8.1 **DA 2017/575 - Review of Determination - 3 Suncrest Avenue.DOC**

DAP ASSESSMENT REPORT

File Reference	DA: 2017/575
Applicant	Techton Building Services
Property	Lot: 73 DP: 240225, 3 Suncrest Avenue ALSTONVILLE
Proposal	Secondary Dwelling as depicted in plans prepared by Techton Building Services Project No. AGSabode1 dated September 2017
Effect of Planning Instrument	The land is zoned R2 under the provisions of the Ballina Local Environmental Plan 2012 (BLEP) and affected by Development Control Plan 2012 (DCP).
Locality Plan	The subject land is depicted on the locality plan below.

**Re: Section 8.2 Review of Determination Application No. 2017/575
3 Suncrest Avenue, Alstonville – Lot 73 DP 240225**

Element C - Building Envelopes

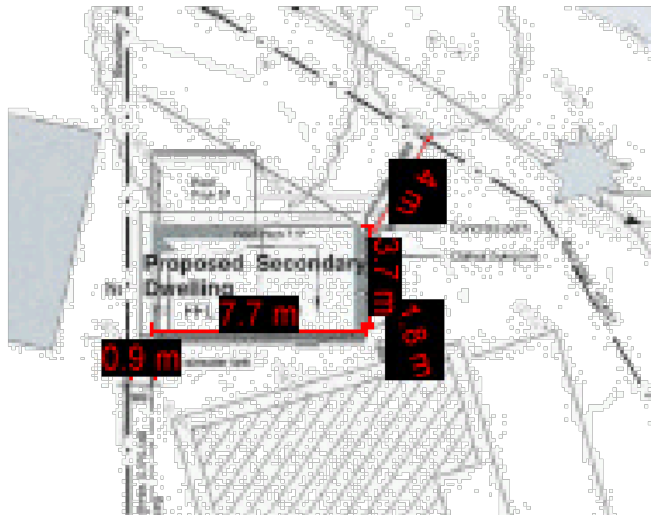
The proposed design is a low set building to be constructed near ground level with a low pitched roof. It is to be set back a minimum of 0.9m from the nearest boundary and complies fully with the building envelope controls

Elevations & Section			
Project number	AGSAbode1	A03b	3/6
Date	Sept17		
Drawn by	CW	Scale 1 : 100	
Checked by	CC	© Copyright

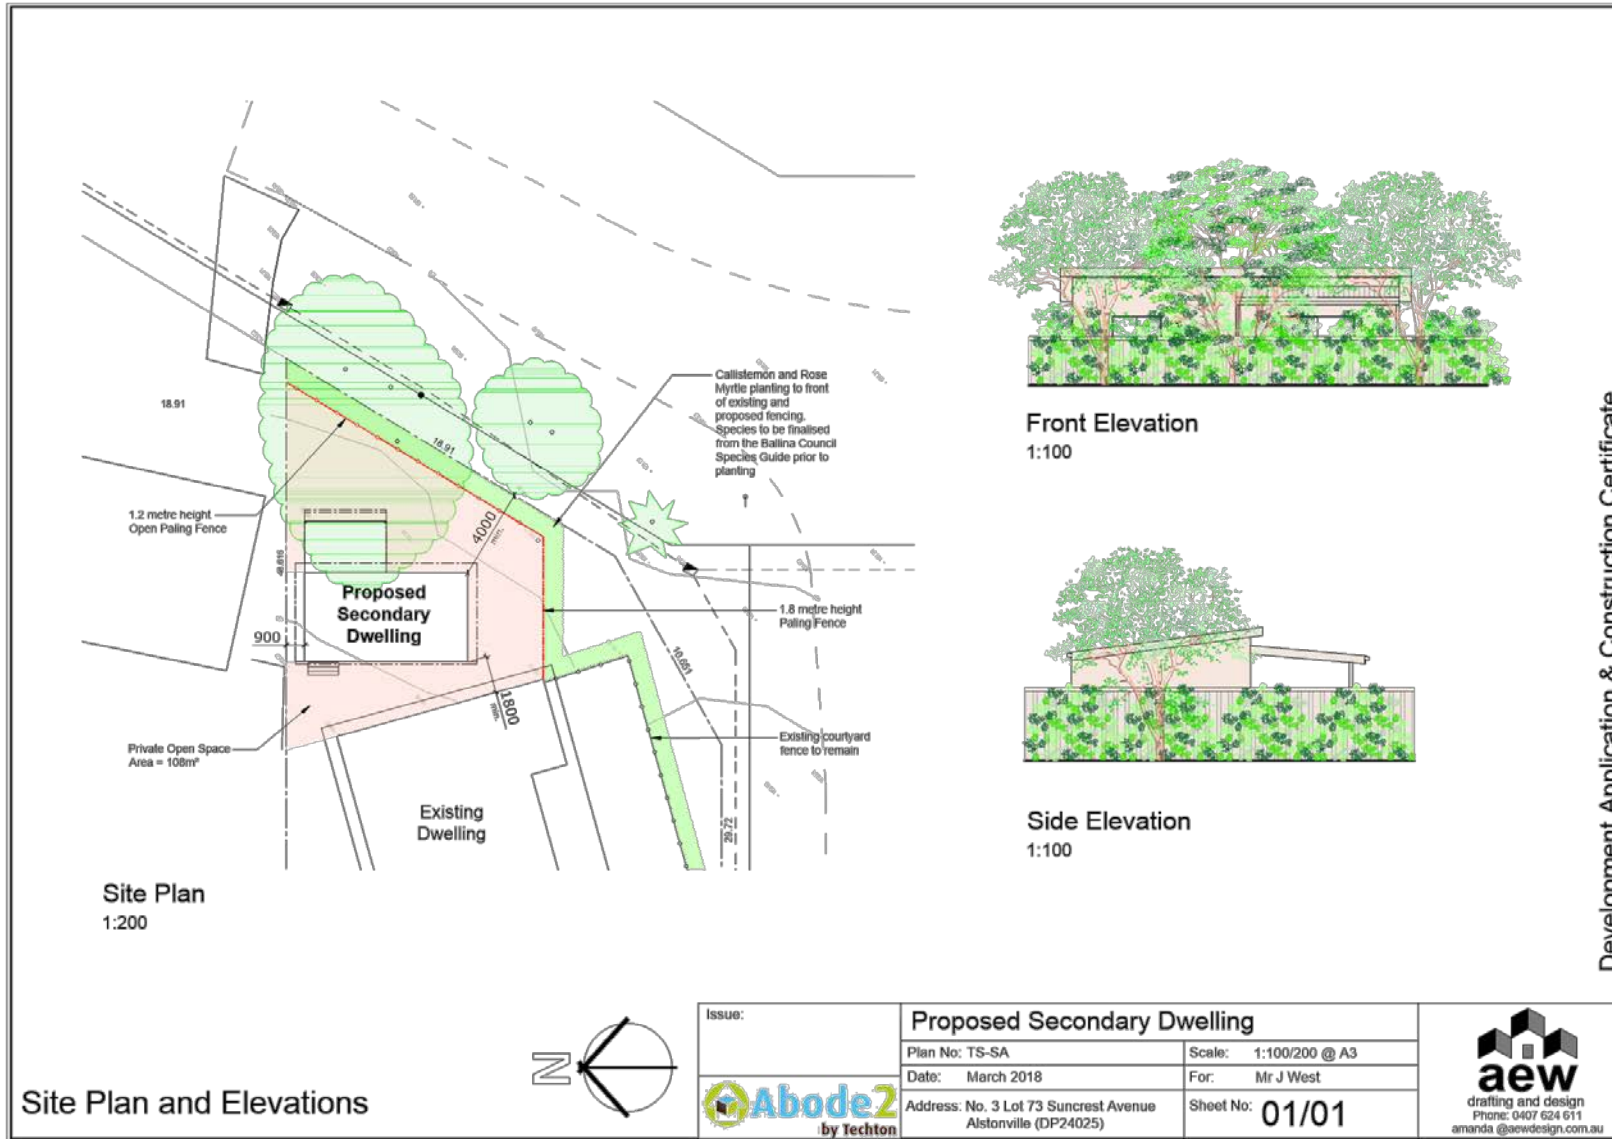
2. A more suitable and reasonable location exists on the property that would provide greater amenity and less impact on the streetscape.

- has eaves running around the dwelling,
- The clothes line has been relocated to the western elevation as illustrated in the attached plan set, and
- is constructed of modern contemporary materials.

No.	Description	Date
1	DA	05/04/16
2		
3	amended clothes line	12/03/18
4	removed landscaping	14/03/18
5
